FPL

L-2002-030
10 CFR 50.90

Re: Turkey Point Units 3 and 4
Docket Nos. 50-250 and 50-251
Proposed License Amendments
Surveillance Testing 4.1.1.2.g.7 Change for Performing
The 24-Hour Emergency Diesel Generator Functional Testing
During POWER OPERATION
Response to Request for Additional Information

FIGURE 1
TURKEY POINT SIMPLIFIED ONE LINE DIAGRAM

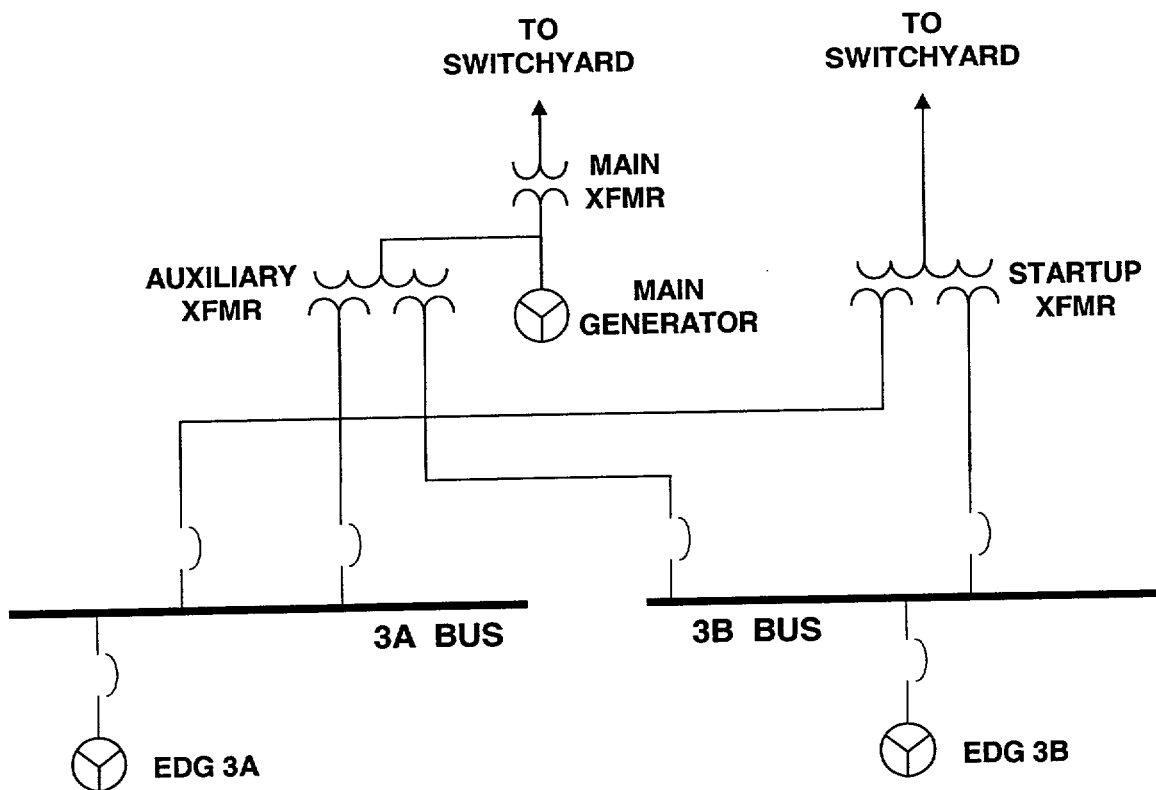
NRC Question #1: Please describe the various events that can cause loss-of-offsite power (LOOP) while the emergency diesel generator (EDG) is being tested and paralleled to offsite power. In addition, please provide a sequence of events, including timing, assuming that the EDG protective features actuates in response to a LOOP.

FPL Response #1: A simplified one-line diagram of the safety related 4 kV buses is provided below as Figure 1. In order for the bus to experience a LOOP, both the auxiliary and startup transformer breakers must be open. During unit operation, power to the safety-related buses is supplied by the auxiliary transformer. Therefore, the plant response while the EDG is being tested and paralleled to offsite power will be addressed based on the auxiliary transformer breaker being closed initially. Opening of the auxiliary transformer breaker would be the result of one the following:

The opening of the auxiliary transformer breaker in response to a safety injection signal will generate a fast bus transfer to the startup transformer. The safety injection signal also opens the breaker for the EDG being tested. Should the fast bus transfer fail, the bus would experience a LOOP. The LOOP would be sensed by loss of voltage relays and all load breakers on the associated bus would then be opened by the emergency bus load sequencer. This would be followed by reclosing of the EDG breaker and loading of accident and safe shutdown loads by the emergency bus load sequencer.

The main generator and main transformer lockout relays are actuated by numerous events as listed in the original Proposed License Amendment submittal. A grid-generated LOOP would likely result in actuation of one or both of these lockout relays. Actuation of these lockout relays will generate a fast bus transfer to the startup transformer. The main generator and main transformer lockout relays also open the breaker for the EDG being tested. If the fast bus transfer fails or if offsite power is not available from the switchyard, the bus would experience a LOOP. The LOOP would be sensed by loss of voltage relays and all load breakers on the associated bus would then be opened by the emergency bus load sequencer. This would be followed by reclosing of the EDG breaker and loading of safe shutdown loads by the emergency bus load sequencer.

An overcurrent trip of the auxiliary transformer breaker would be the result of a bus fault based on electrical fault coordination with the bus load breakers. Such an overcurrent trip would result in a bus lockout. The bus lockout trips the breaker for the EDG being tested in order to prevent potential damage to the EDG. No fast bus transfer will take place and the bus will remain de-energized until the cause of the bus fault is identified and corrected.

The spurious or inadvertent opening of the auxiliary transformer breaker would not result in a fast bus transfer or tripping of the EDG breaker. The EDG being tested would attempt to provide power to all connected bus loads and be subject to an overload condition. This would likely result in a relay race between the bus undervoltage protection and the EDG protective trips. Based on the proposed assumption that an EDG protective feature actuates first, the following sequence of events will occur.
